Alexandria Residents Action Group (ARAG) strongly objects to this proposal.

Illustration 4: From Davey St, only Sheds 14 and 15 will be visible

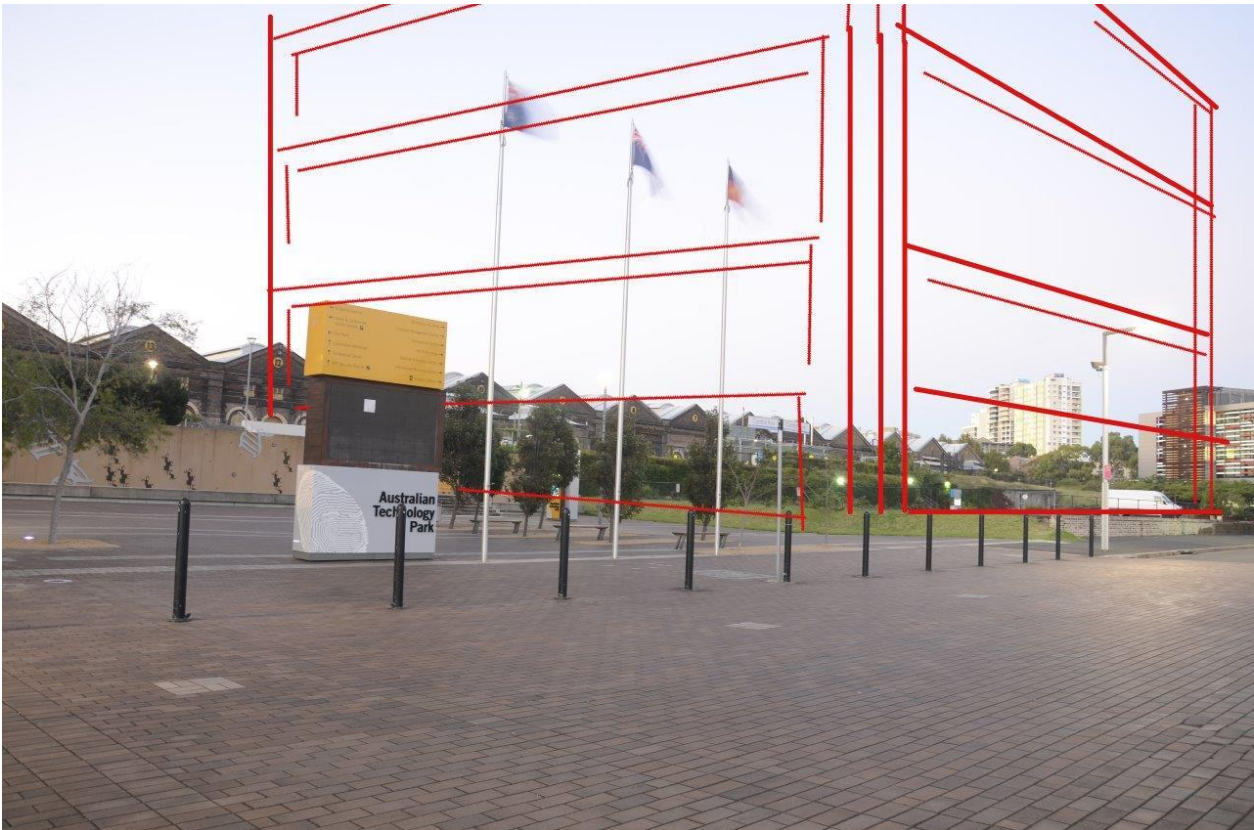
What the EIS does not acknowledge is that Building 2, and to a lesser degree Building 1, will block views of the Eveleigh Rail Sheds, which are indeed iconic. The current view can accurately be described as panoramic. Viewed from Central Avenue, the view stretches from Shed 1 to Shed 15. Even from Henderson Road, the view stretches from Shed 15 to Shed 7. All this will be lost.

From Davey St, only Sheds 14 and 15 will be visible, as shown below. Elsewhere, the view will be completely lost behind Building 2. The SEARS requires "view analysis to and from the site from key vantage – points and streetscape impacts". Such a deliberately selective, limited, unrepresentative and misleading sample of the vantage points does not meet the letter or spirit of the SEARS, and deserves condemnation for treating the process with more than a degree of contempt. It raises the question of which other aspects of the applicant's response are similarly incomplete.
